Document number
BGLI08:494
Date
2008-06-05
Remarks

Revision
A

HW change description for

Mobile Station Type:
AAD-3252041-BV W760i
HW (B)

2.1 Antenna Element Change

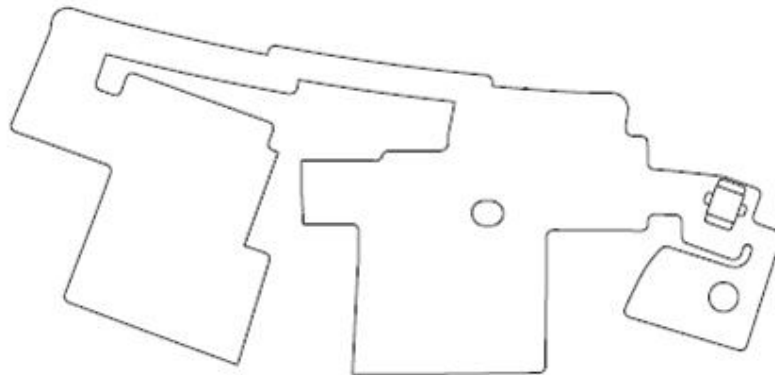
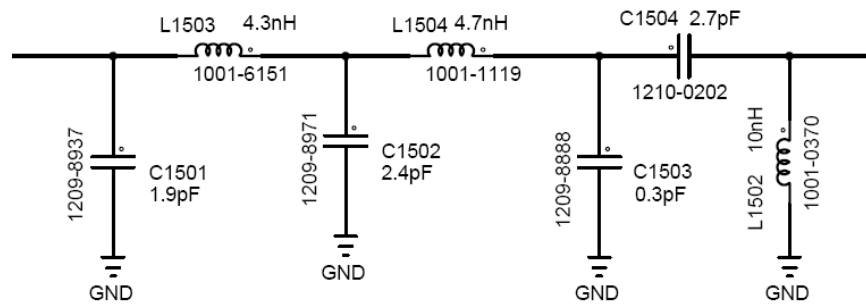
Note the array of components surrounding the larger coax connector. These were intended to be used for a “pre-distortion” matching circuit between the antenna element and the coax cable.

For HW-B, the element shape has changed and the pre-distortion matching circuit has been eliminated.

2.2 Antenna Matching Circuit

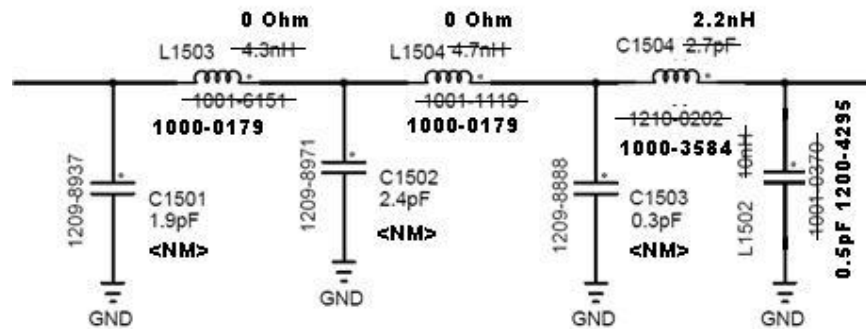
HW-A used a 7 component LCCLCLC matching circuit. HW-B uses only a 2 component CL circuit. For HW-B, C1501 through C1503 are no-mounted (<NM>) and L1503 and L1504 are replaced with 0 ohm resistors. C1504 is replaced with a 2.2nH inductor and L1502 is replaced with a 0.5pF capacitor.
